REVISION 001 TO A INVITATION TO TENDER

Title - Sujet : Illecillewaet Stone A	rch Culvert – Gl	acier	National Park
Solicitation No N° de l'invitation : 5P420-19-0109/A		Date : June 24, 2019	
Amendment No N° 001	de modification		
Client Reference No. N/A	- N° de référence	e du c	lient :
GETS Reference No. PW-19-00877005	N° de reference	de S	EAG :
Solicitation Closes - L'invitation prend fin : At - à : 2 :00 PM On - le : June 26, 2019			Time Zone - Fuseau horaire MDT - HAR
F.O.B F.A.B. : Plant - Usine : □	Destination : 🛛	Oth	ner - Autre : 🗆
Address Enquiries to à : Rebecca Chen	o - Adresser toute	es de	mande de renseignements
Telephone No N° de telephone : (587) 439-3529	Fax NoN° de télécopieur : (866) 246-6893		Email Address – Couriel : rebecca.chen2@canada.ca
Destination of Goods biens, services, et co Glacier National Park See Herein – Voir ici		Const	ruction - Destination des
TO BE COMPLETED SOUMISSIONNAIRE	BY THE BIDDER	- À R	EMPLIR PAR LE

Amendment 001

Figure 1&2: Left inlet August 2, 2016

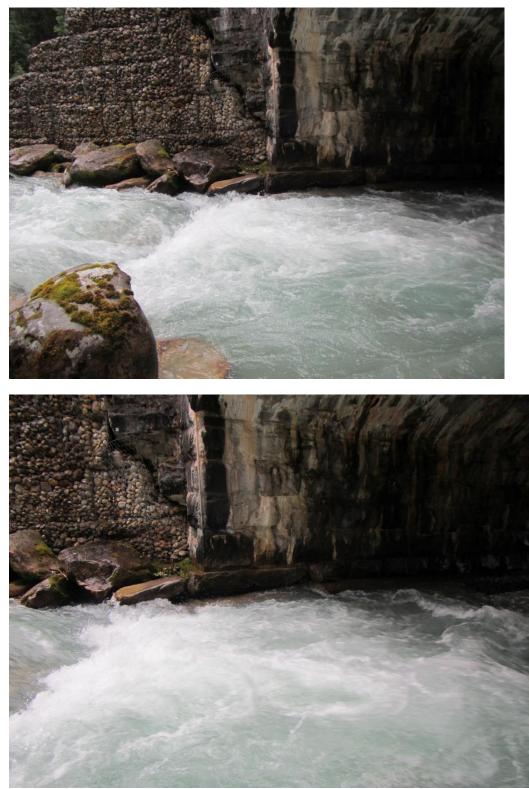
Q4 What is the timeframe for this project?

A4 Following Department of Fisheries and Oceans recommendations, to avoid impacts to potential fishspawning habitat all in-stream work would need to take place before August 31. Water levels (see below: Site Photos August 2, 2016) will likely still be high in August. We are still awaiting final recommendations/decisions from Department of Fisheries and Oceans regarding this project. Ideal lowlevel water timeframe would be September to end of October (however this is in the fish-spawning window). While water levels are low in the spring, access at this time is not an option as access to the site is limited by snow and avalanche hazard.
